RECEIPT DATE: 12/18/12 **ONSITE SEWAGE DISPOSAL SYSTEM** P 544460

PROPERTY ADDRESS: 11247 Independence Way

SUBDIVISION: Homewood Crossing LOT: 87 TAX ID: 05-443482

**WALLCHECK LOT# 87
 HOMEWOOD CROSSING**

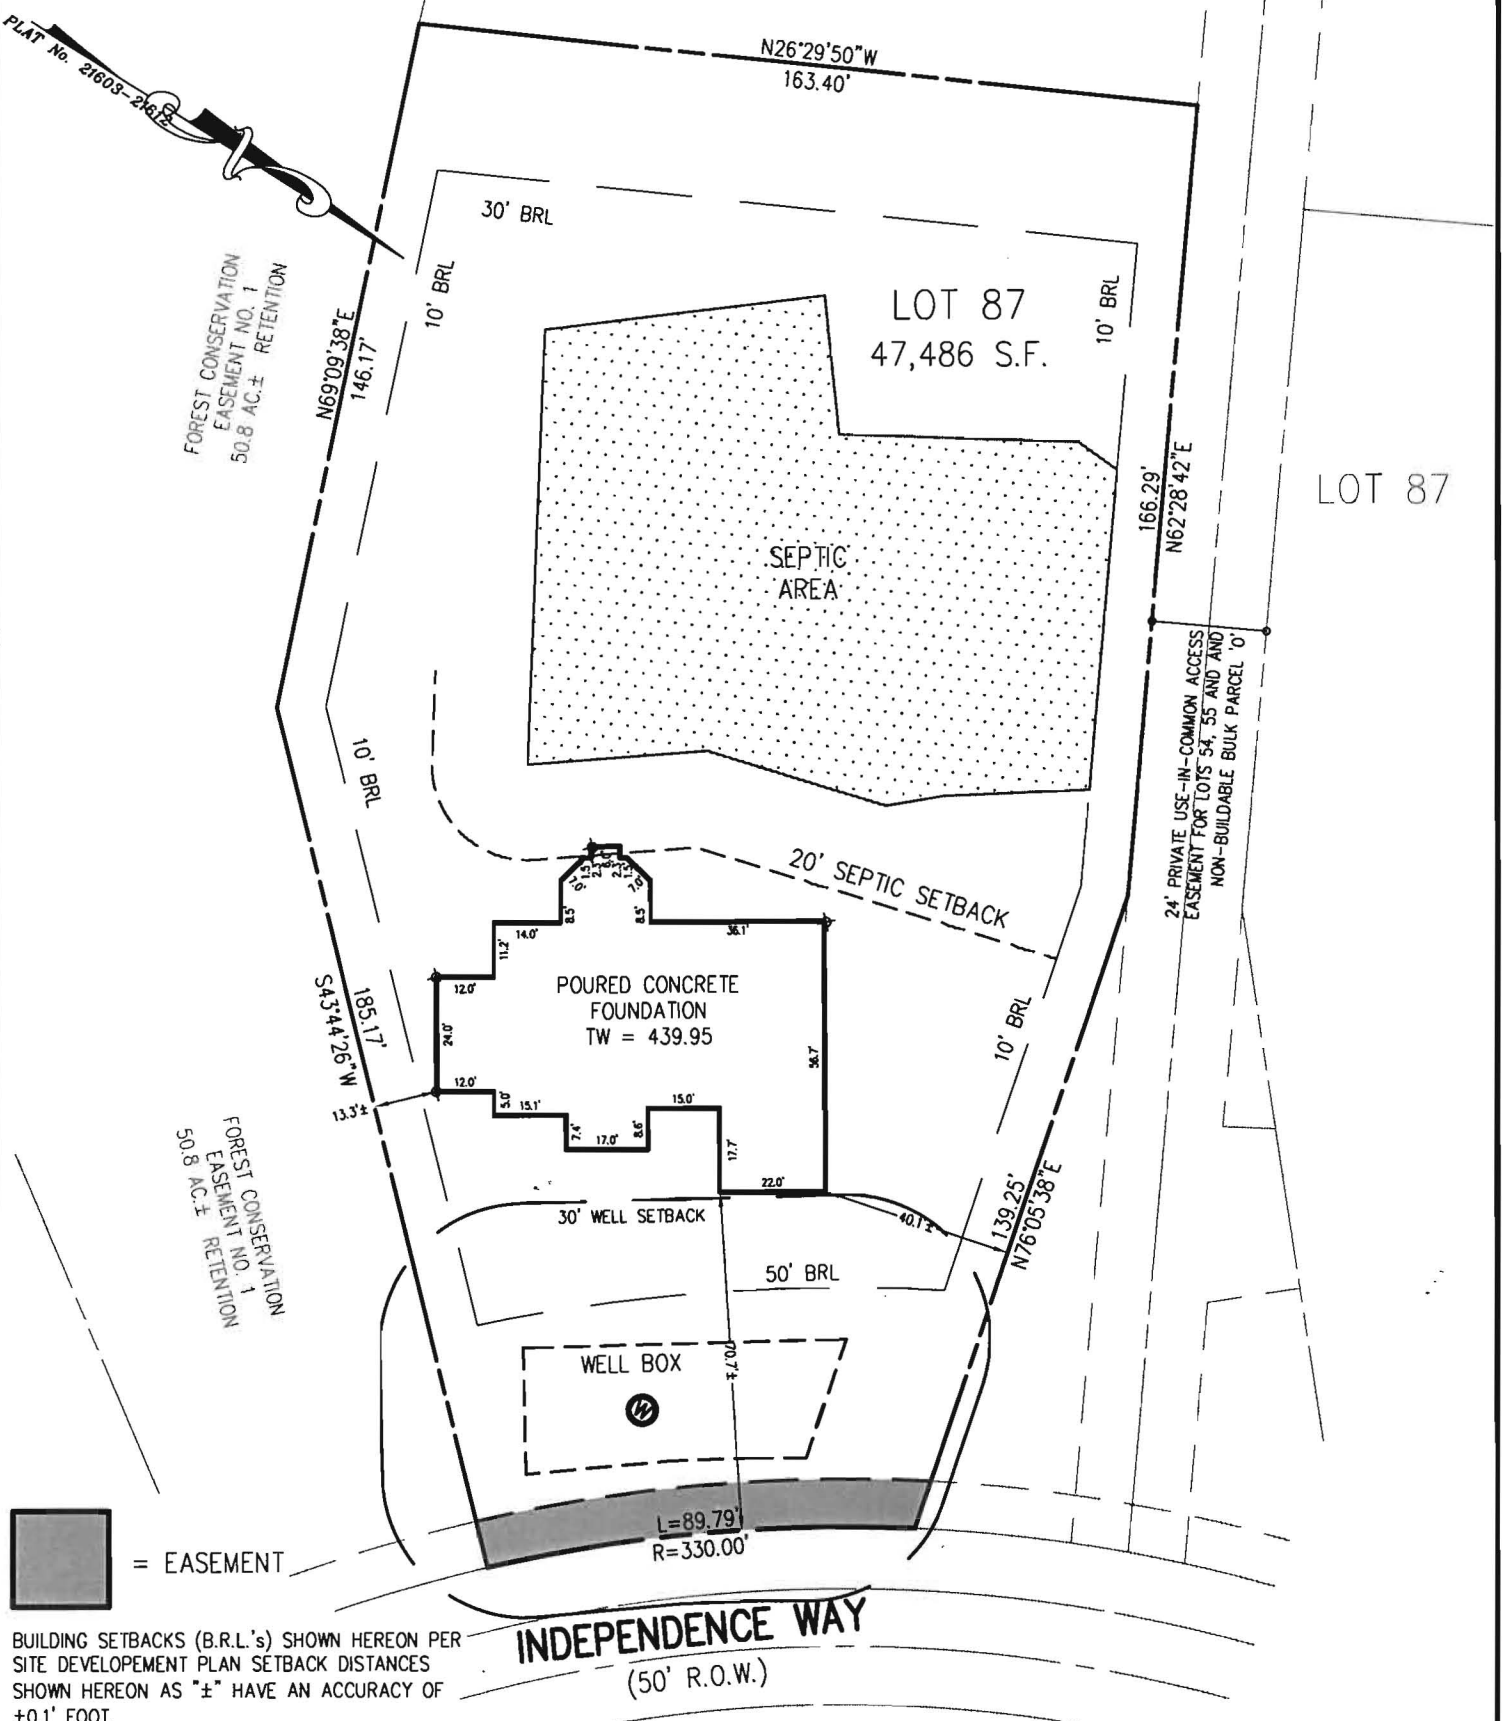
TRENCHES:	LINEAR FEET REQUIRED: <u>207.5 175'</u>	INLET DEPTH: <u>3'</u>
	TRENCH WIDTH: <u>2</u>	MAXIMUM BOTTOM DEPTH: <u>7.5'</u>
	MINIMUM SPACE BETWEEN TRENCHES: <u>9</u>	EFFECTIVE AREA BEGINNING DEPTH: <u>5'</u>
LOCATION:	PER APPROVED SITE PLAN. SEWAGE DISPOSAL AREA AND BAT UNIT LOCATION MUST BE STAKED BY LICENSED SURVEYOR PRIOR TO PRE-CONSTRUCTION INSPECTION.	
NOTES:	Set septic tank per layout inspection. <u>50', 60', 65'</u> ~ 100 feet stone. Set distribution box per layout inspection. Install 207.5 feet of trench on contour.
